# GRANDVIEW RESERVE

EL PASO PDC FILE NO.  
CDR-228

GRANDVIEW RESERVE  
DR HORTON  
FALCON, COLORADO

CONSTRUCTION DOCUMENTS  
TITLE SHEET

SHEET  
TS1  
01

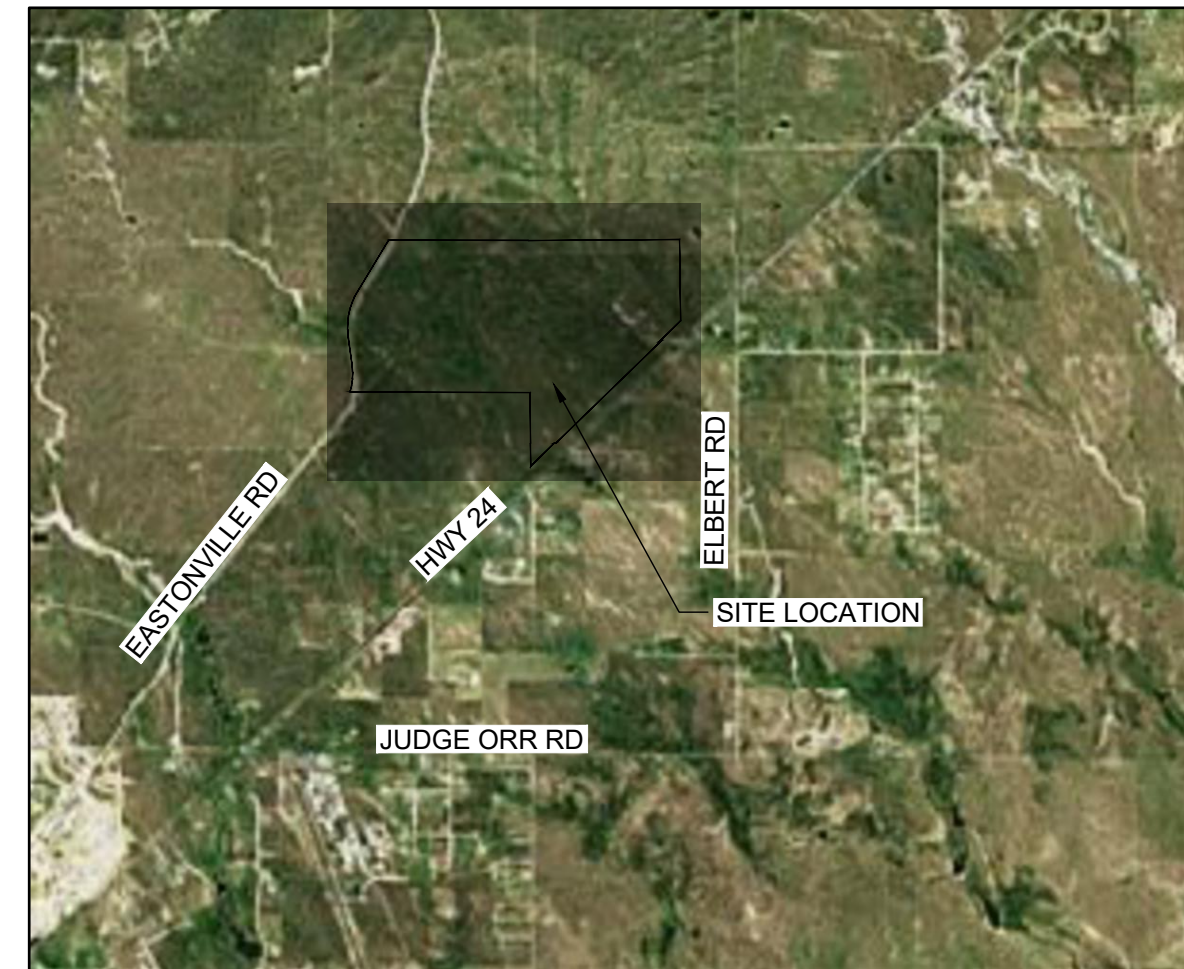
Include name of channel section

Add statement that ownership and maintenance is by the Grandview Metro District

Add a little more space for signatures

SHEET  
**GR18**  
 22

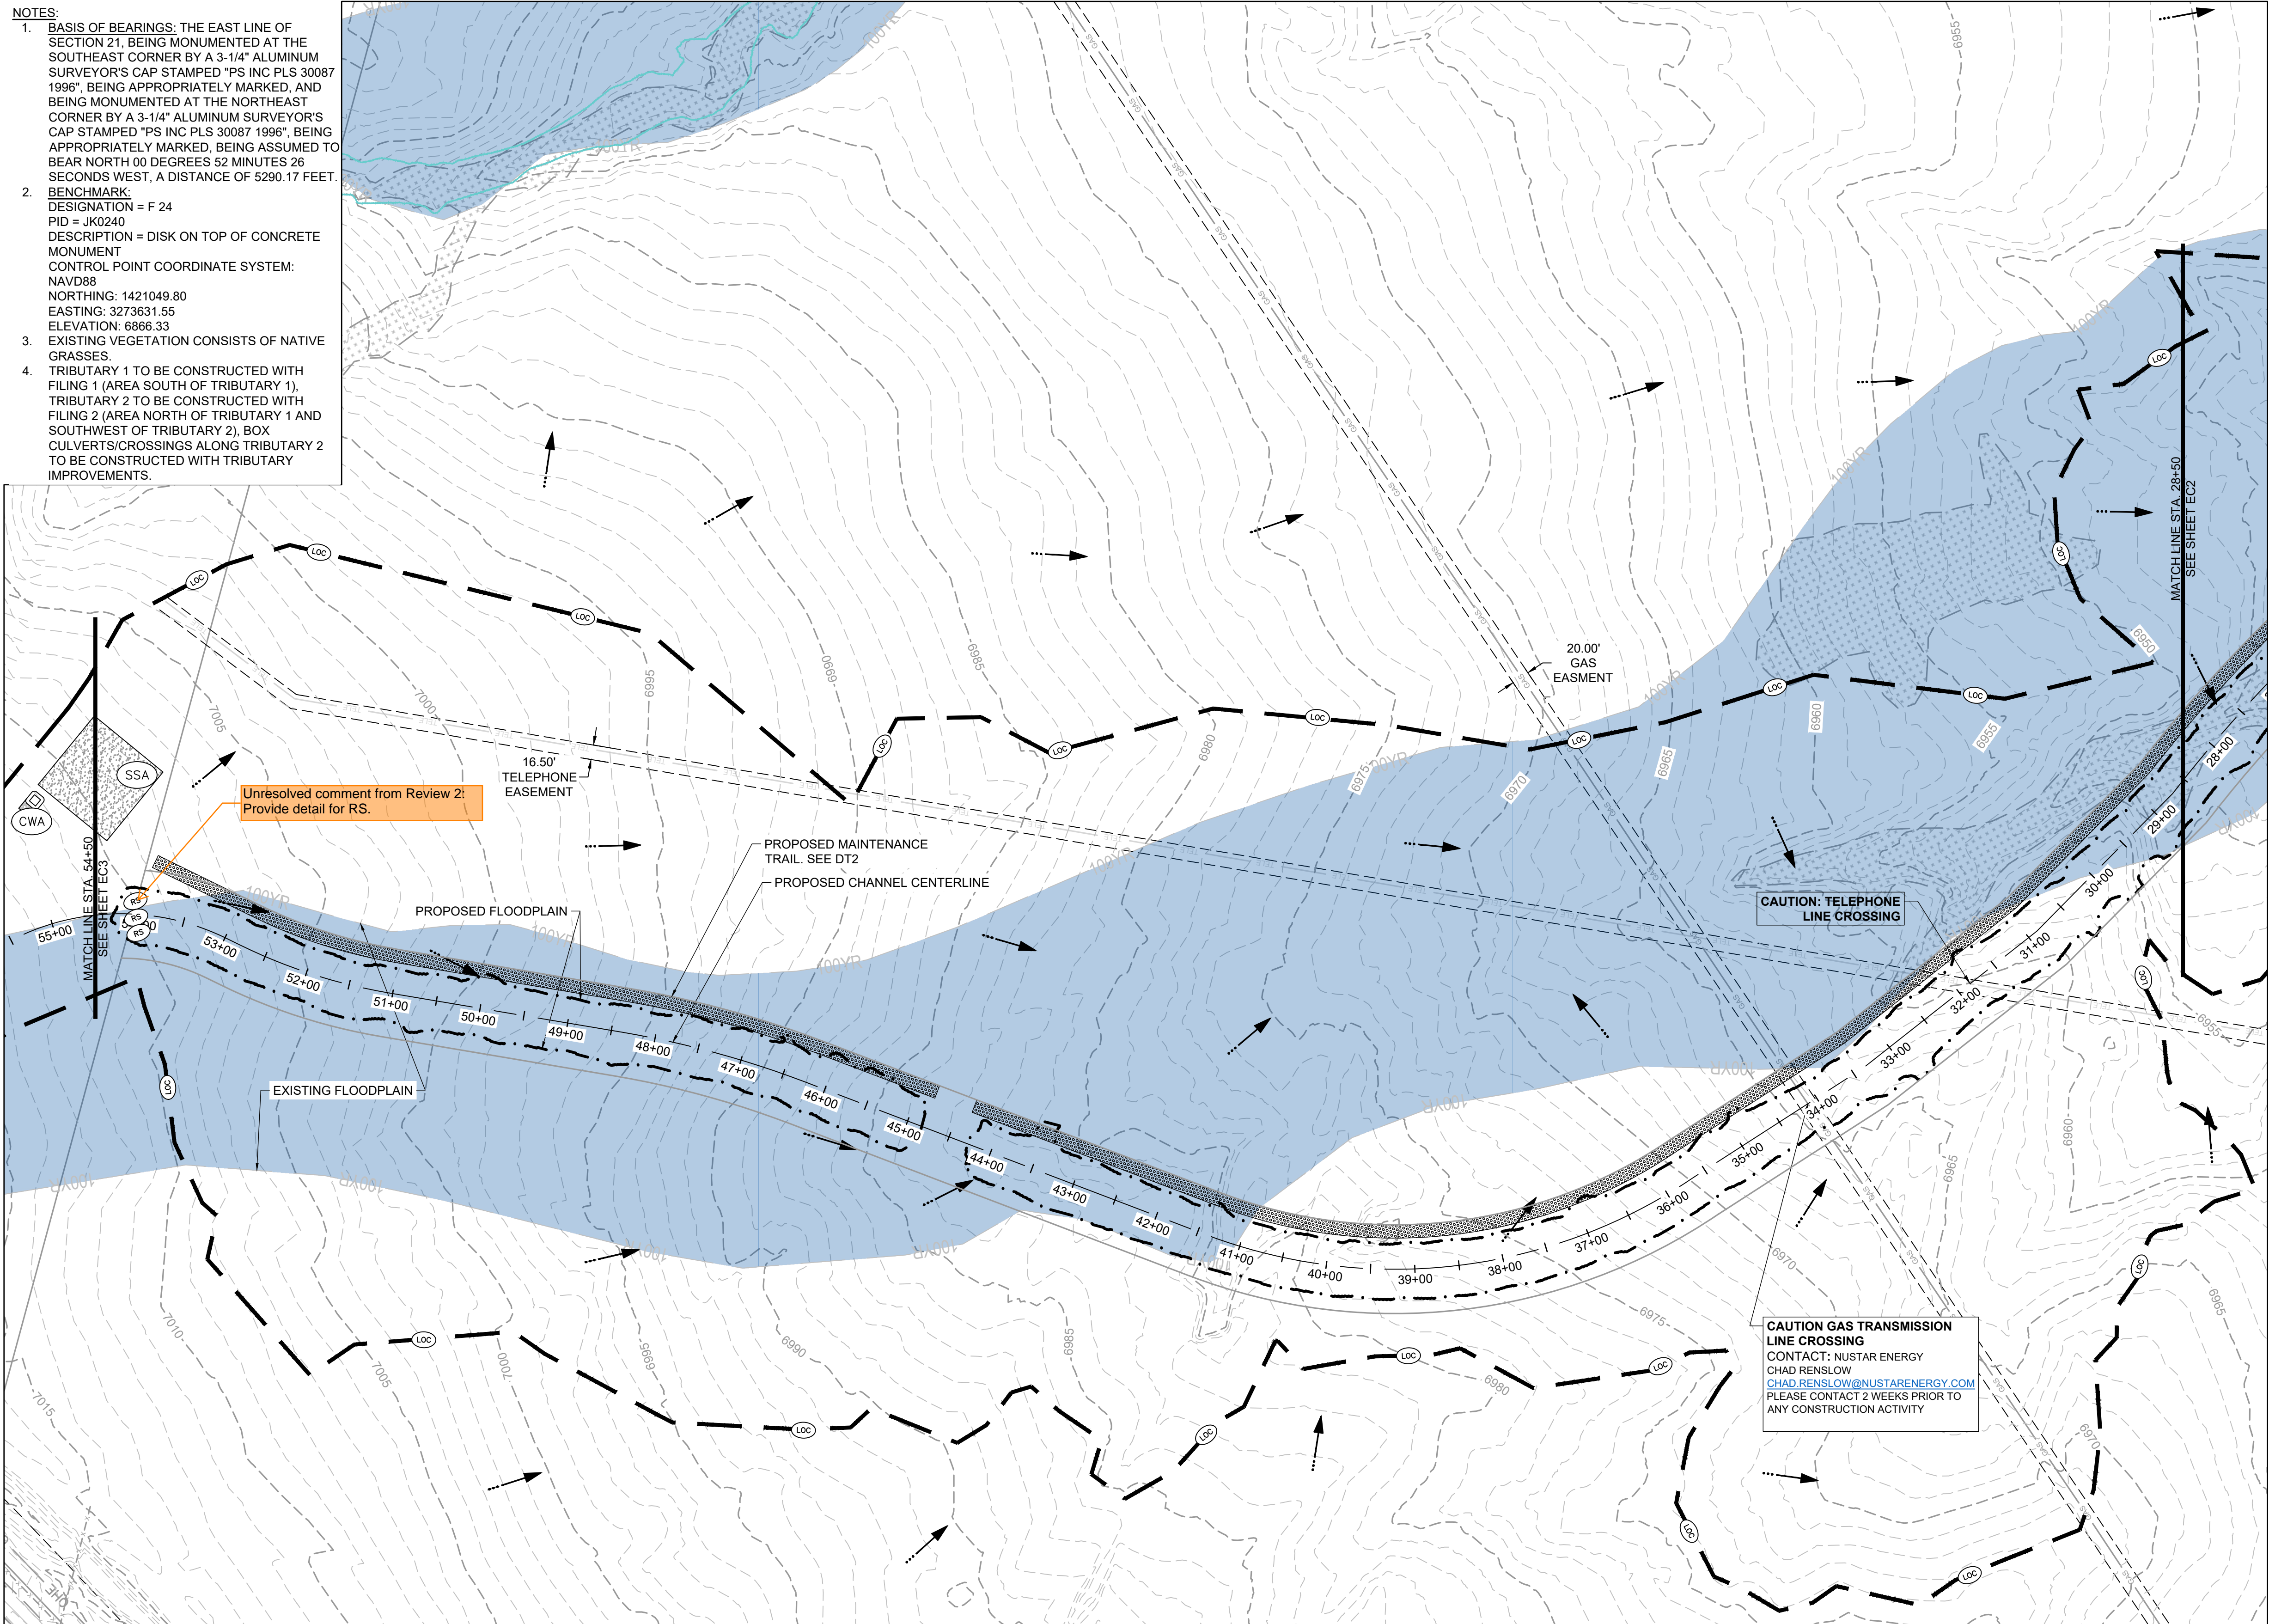
Not seen on plans. Is there a location that would be appropriate or will there be VTCs elsewhere in F1 & F2? Show on plans or add a note of VTC location(s) if off of plan limits.

SHEET  
 PP2  
 31

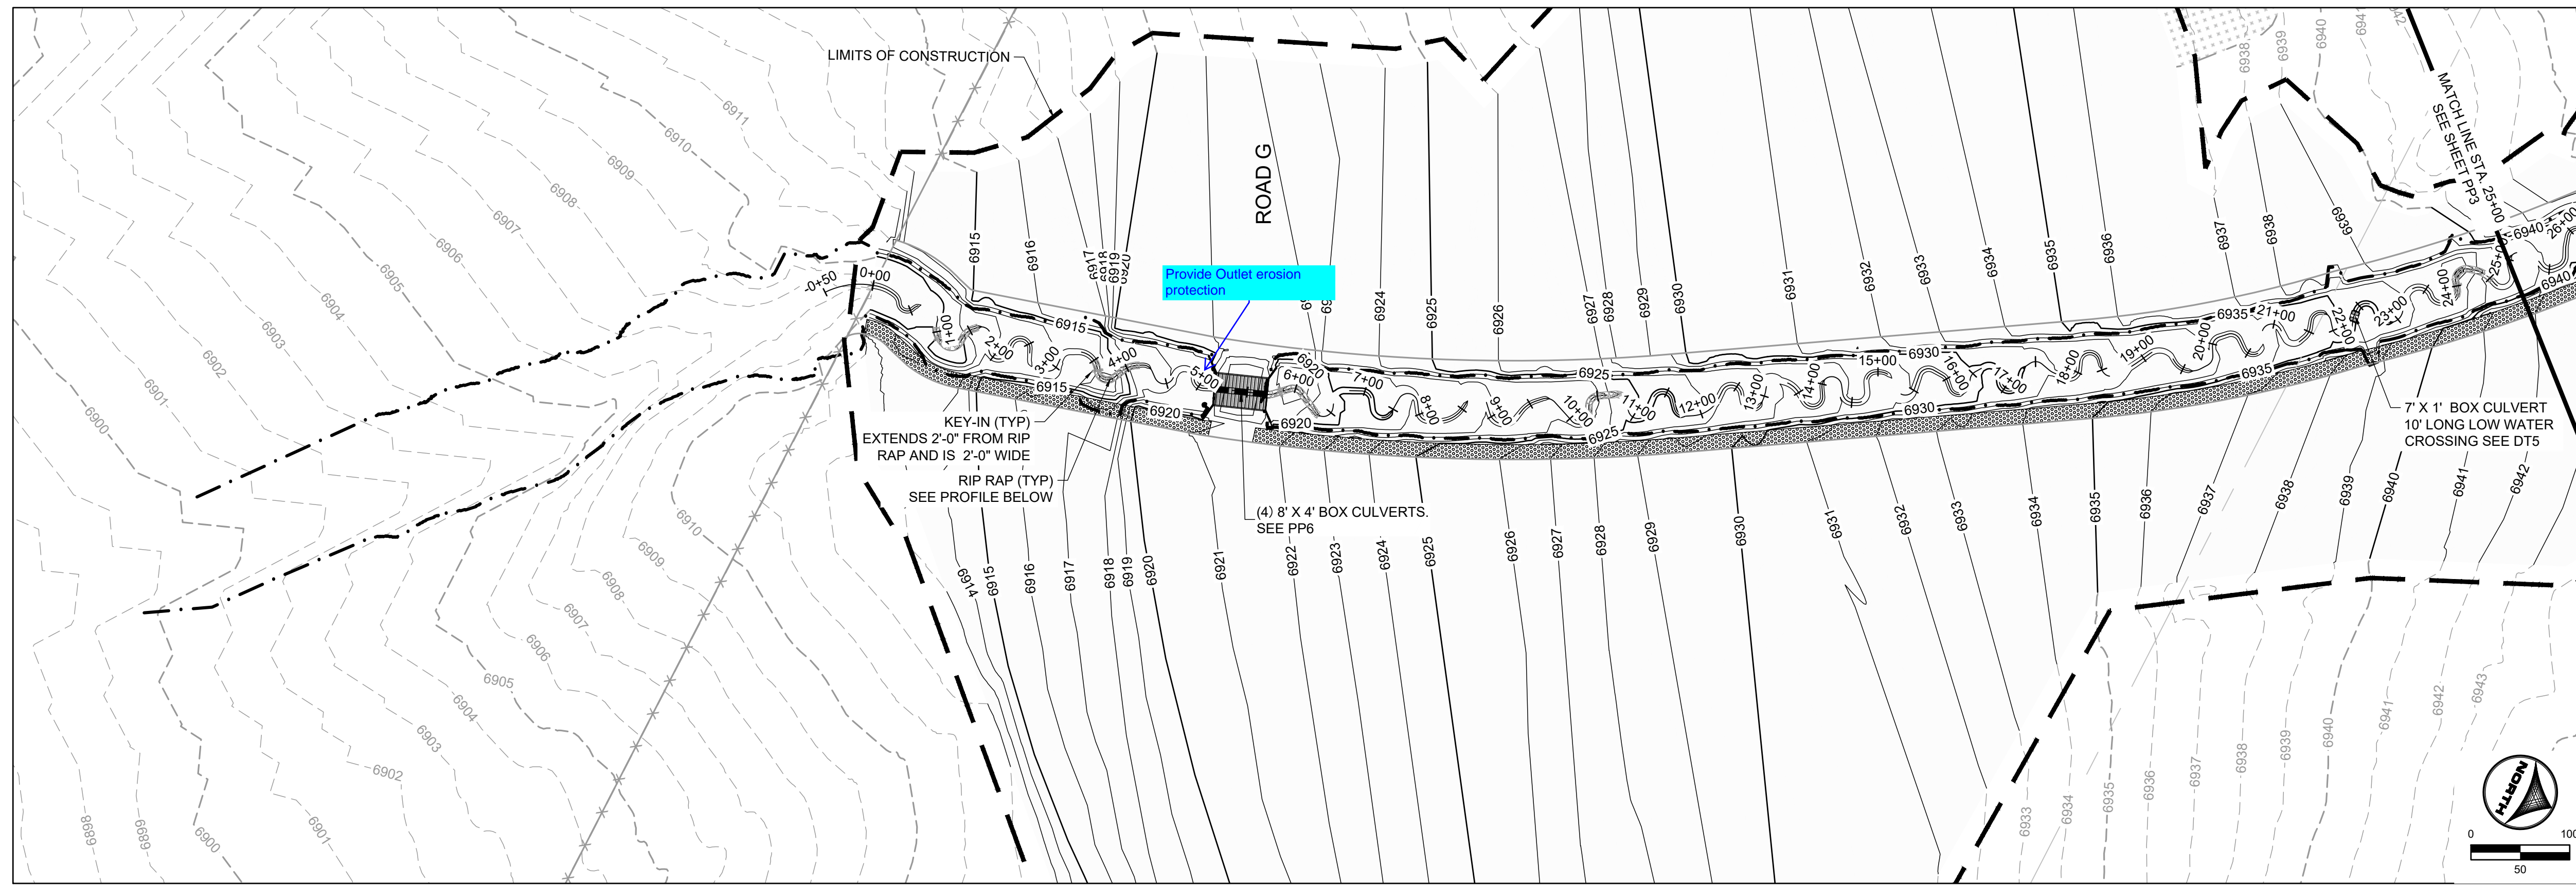
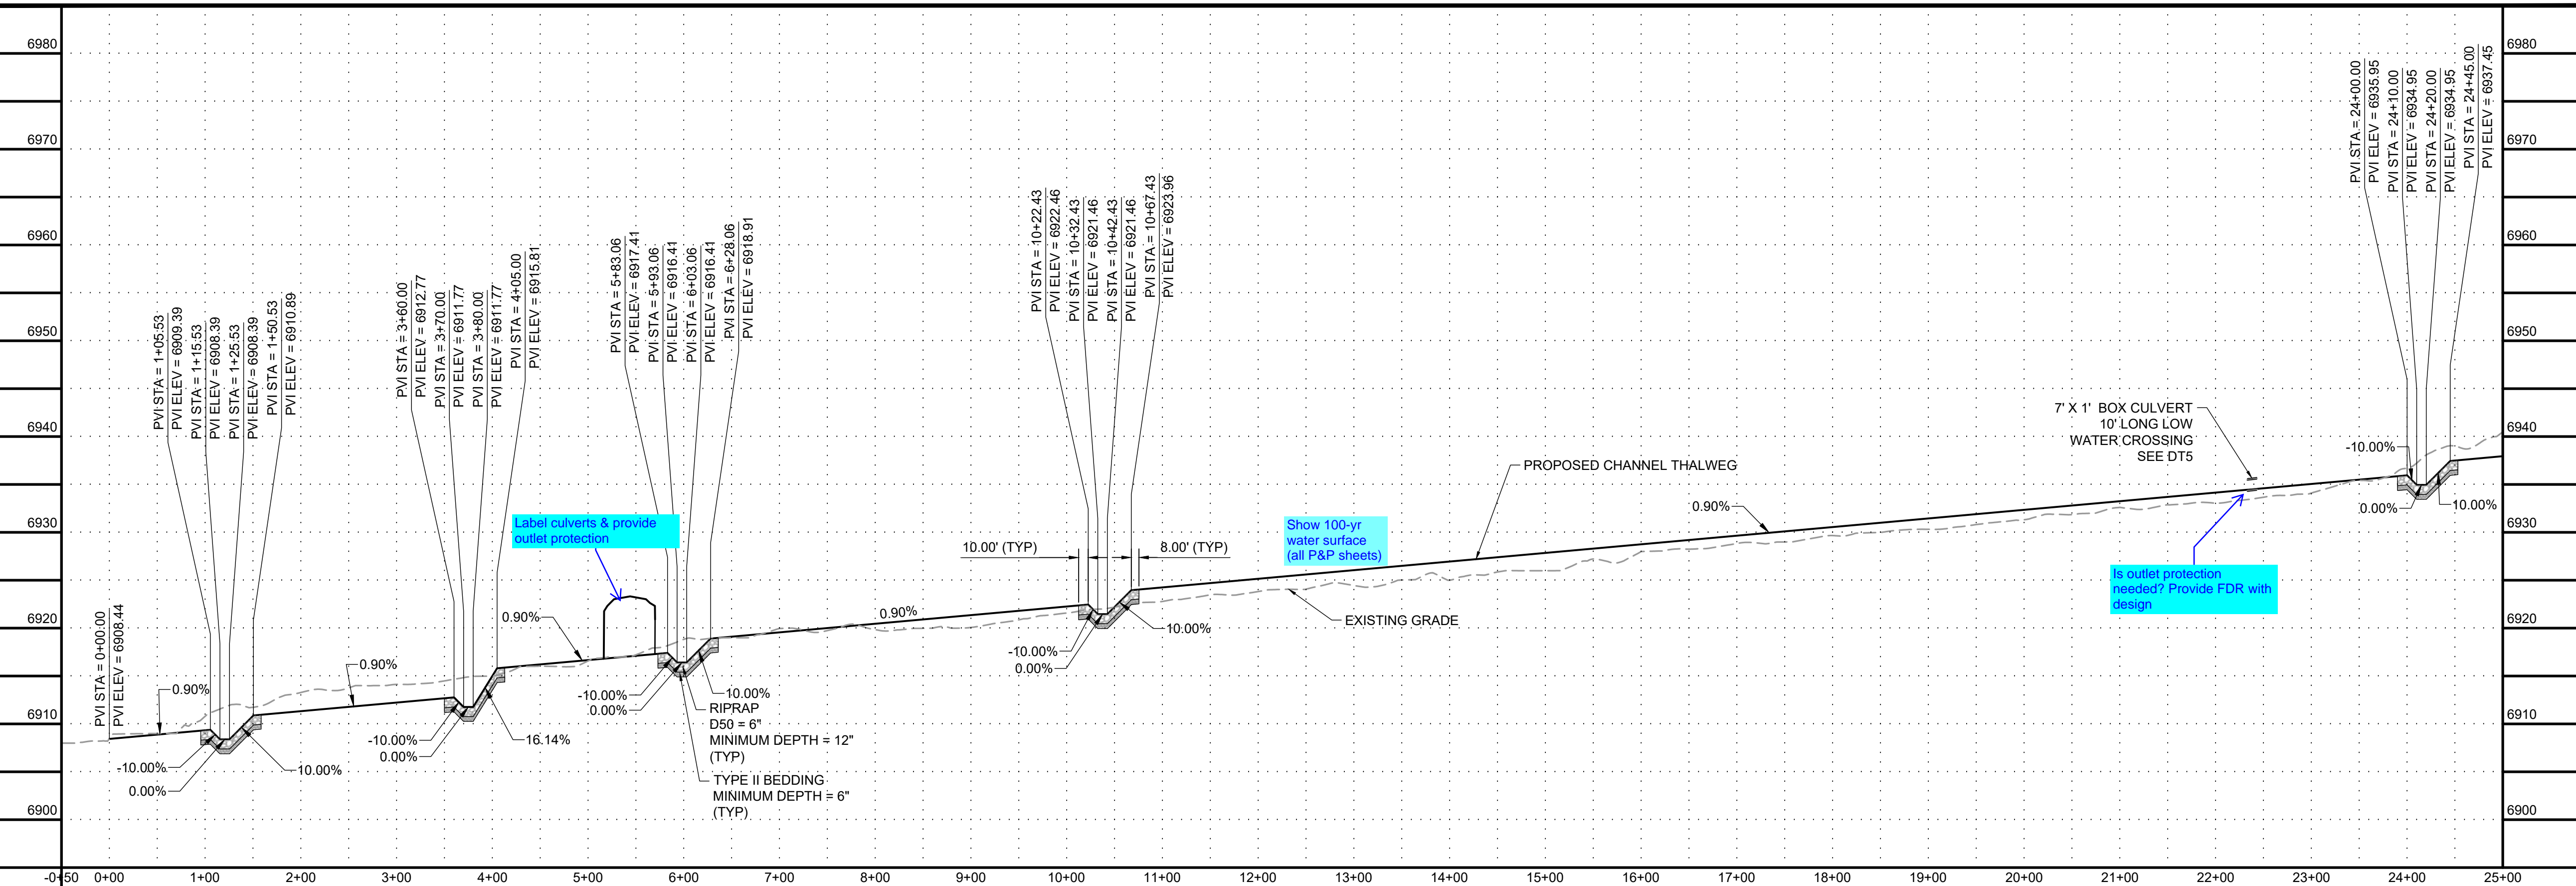
Add blue hatching back in for effective 100-yr floodplain, as used on previous submittal (all P&P sheets)
